Change Notice

Changes to ITO Film for FT Series Analog Resistive Touch Screens

Cross Section View of Touch Screen	Before Change	After Change
	<p>Surface Hardness: 2H (JIS K 5600)</p>	<p>Surface Hardness: 3H (JIS K 5400)</p>

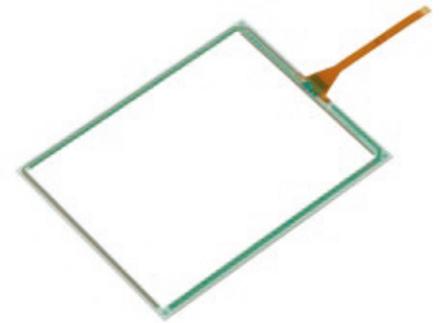
FT Series Touch Screens will be undergoing changes to the ITO film (top electrode). This revision will apply to the four-wire analog resistive touch screens, the four-wire analog resistive touch screens with FPC tails, and the five-wire analog resistive touch screens, both standard and custom models. The hardness of the film, previously 2H, will be changing to 3H. Details are highlighted on the following table.
